MIL-PRF-19500/586M
w/AMENDMENT 4
19 April 2024
SUPERSEDING
MIL-PRF-19500/586M
w/AMENDMENT 3
17 February 2021

PERFORMANCE SPECIFICATION SHEET

SEMICONDUCTOR DEVICE, DIODE, SILICON, RECTIFIER, SCHOTTKY BARRIER, ENCAPSULATED (AXIAL LEADED AND SURFACE MOUNT) AND UNENCAPSULATED, TYPES 1N5817-1, 1N5819-1, AND 1N6761-1, QUALITY LEVELS JAN, JANTX, JANTXV, JANS, JANHC, AND JANKC

* FIGURE 3. Physical dimensions of surface mount 1N5817UDAB 1N5819UDAB.

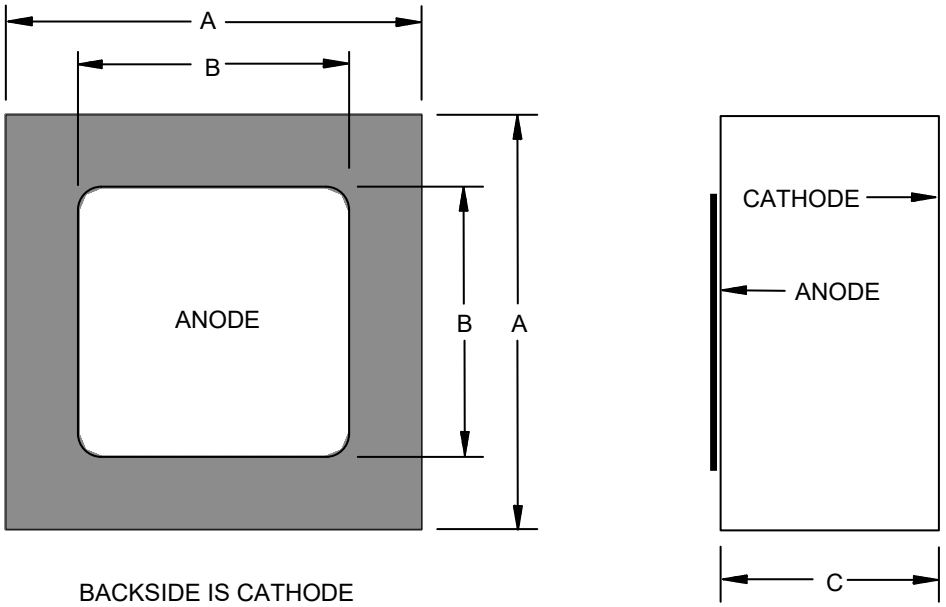
NOTES:
1. Dimensions are in inches. Millimeters are given for general information only.
2. Pad 3 = shielding, connected to the lid.
3. Equivalent pad layout to 1N5819UR-1.
4. Cathode marked with a square.
